**NORTH ANNA POWER STATION
IMPROVED TECHNICAL SPECIFICATION CONVERSION**

CHAPTER 2.0 - SAFETY LIMITS

CHAPTER 2.0 - SAFETY LIMITS
IMPROVED TECHNICAL SPECIFICATIONS

Figure 2.1.1-1 (page 1 of 1)
Reactor Core Safety Limits

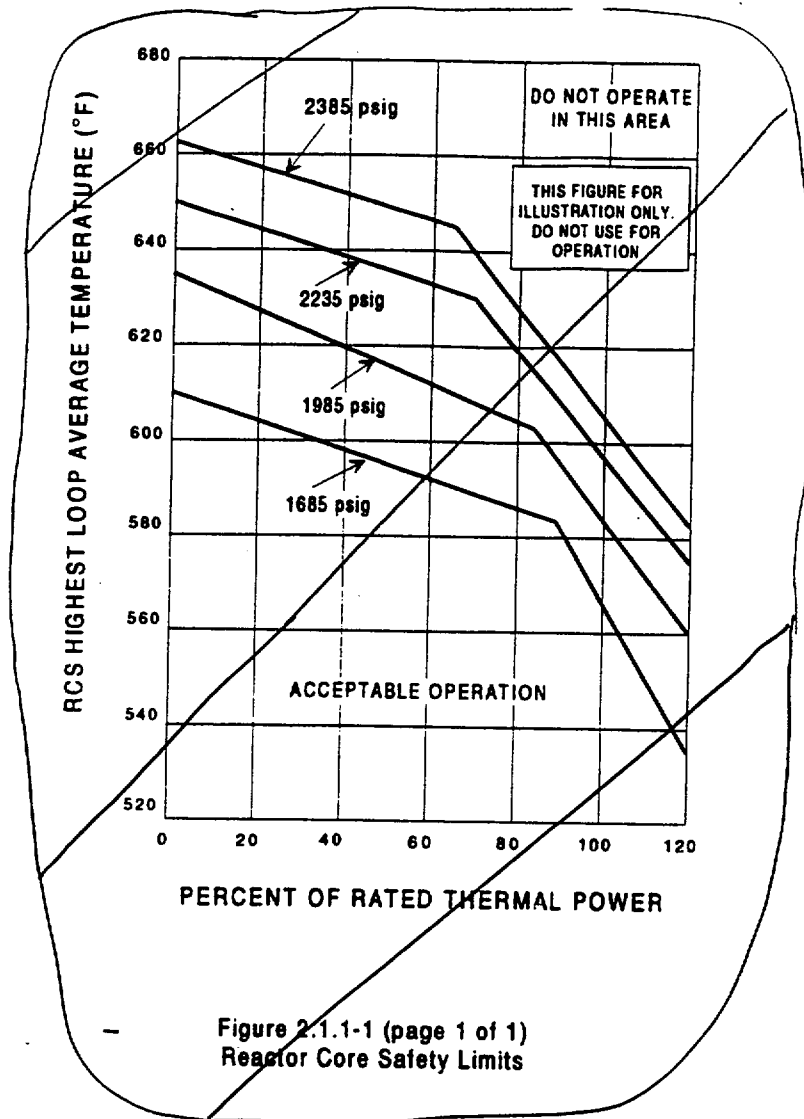
In MODES 1 and 2, the combination of THERMAL POWER, Reactor Coolant System (RCS) highest loop average temperature, and pressurizer pressure shall not exceed the (SLs) specified in Figure 2.1.1-1.

1. The brackets have been removed and the proper plant specific information/value has been provided.

Figure B 2.1.1-1 (page 1 of 1)
Reactor Core Safety Limits vs. Boundary of Protection

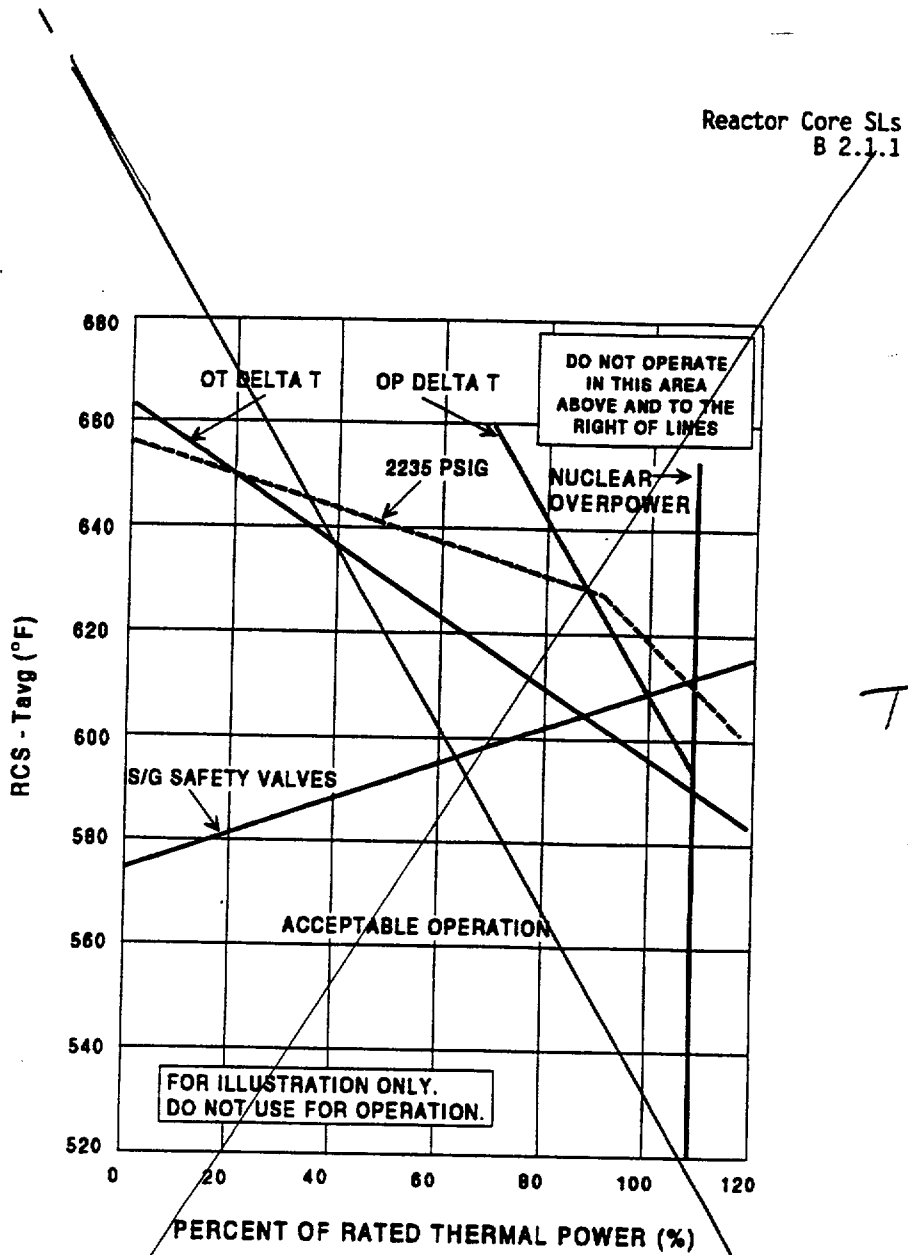
The ~~curves~~ provided in ~~Figure B 2.1.1.1~~ show the loci of points of THERMAL POWER, RCS pressure, and average temperature for which the minimum DNBR is not less than the safety analyses limit, that fuel centerline temperature remains below melting, that the average enthalpy in the hot leg is less than or equal to the enthalpy of saturated liquid, or that the exit quality is within the limits defined by the DNBR correlation.

The curves are based on enthalpy hot channel factor limits provided in the COLR. The dashed line of Figure B 2.1.1-1 shows an example of a limit curve at 2235 psig. In addition, it illustrates the various RPS functions that are designed to prevent the unit from reaching the limit.

Figure 2.1-1 REACTOR CORE SAFETY LIMITS FOR THREE LOOP OPERATION

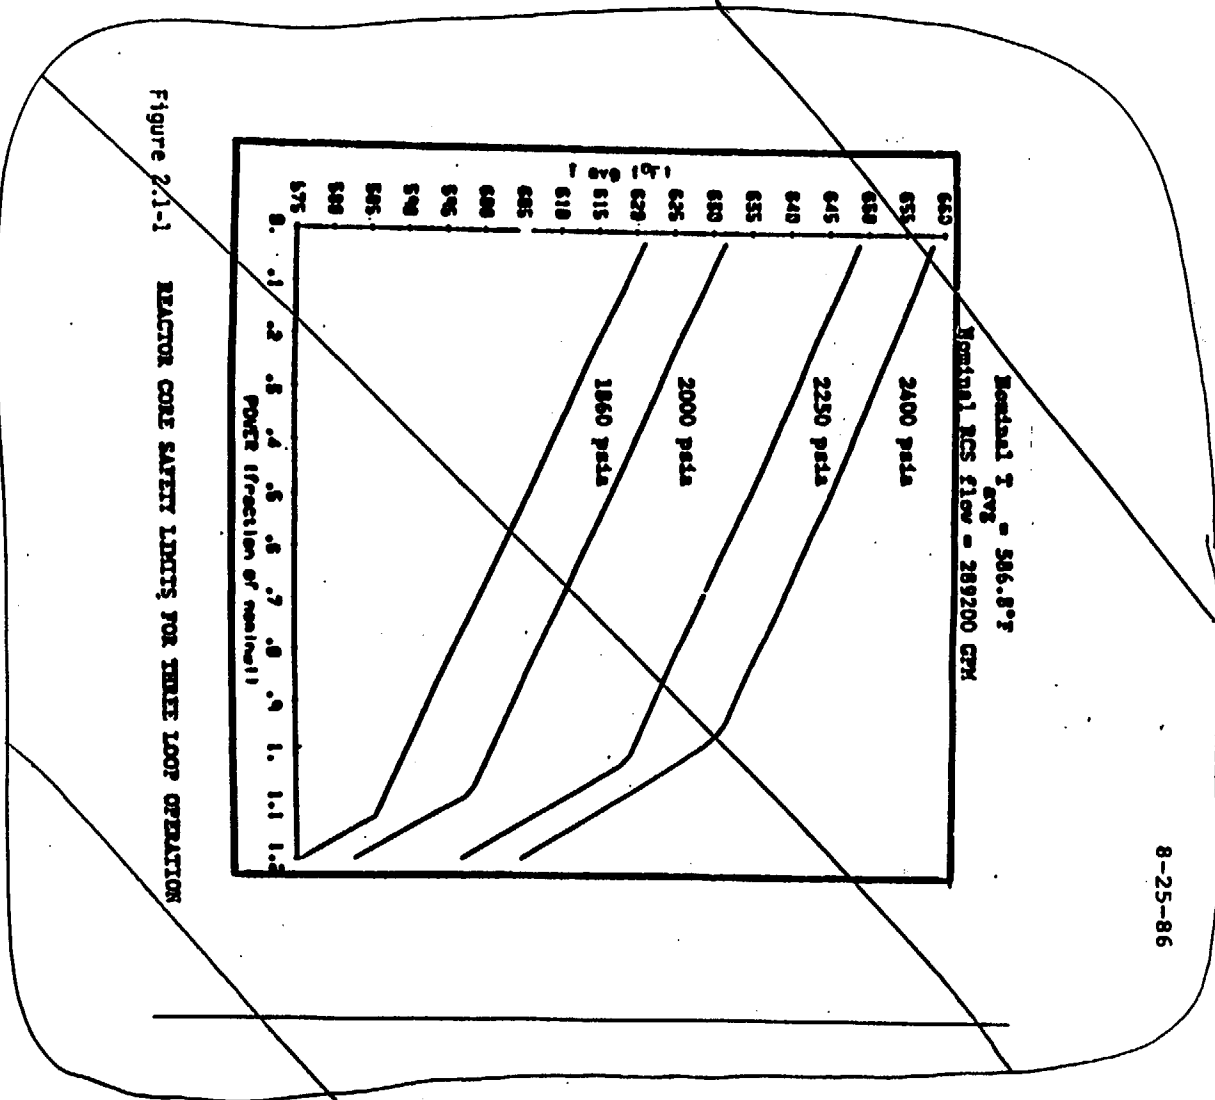
For the period of operation until steam generator replacement, the combination of THERMAL POWER, pressurizer pressure, and the highest operating loop coolant temperature (T_{avg}) shall not exceed the limits shown in Figure 2.1-1a.

- A.2 CTS 2.1.1 references three curves providing limits on THERMAL POWER, pressurizer pressure, and the highest operating loop coolant temperature (Tavg). One curve applies to three loop operation (Figure 2.1-1) and two apply to two-loop operation (Figures 2.1-2 and 2.1-3). In the CTS, Figures 2.1-2 and 2.1-3 are replaced with a note stating, "This page left blank pending NRC approval of ECCS evaluation of two loops in operation with the third loop isolated" and "This page left blank pending NRC approval of ECCS evaluation of two loops in operation with the third loop not isolated," respectively. ITS 2.1.1 does not contain an allowance to operate with less than three reactor coolant loops in operation. This changes the CTS by eliminating references and place holders for curves applying to two-loop operation.

- A.3 Unit 1 CTS 2.1.1 contains a Note and an additional Figure, Figure 2.1-1a, which is to be used for the period of operation until steam generator replacement. ITS 2.1.1 does not contain a similar Note or additional Figure.

This change is acceptable because the North Anna Unit 1 steam generators have been replaced and the Note and the Figure are no longer applicable. This change is designated as administrative because it eliminates information from the CTS that is no longer applicable.
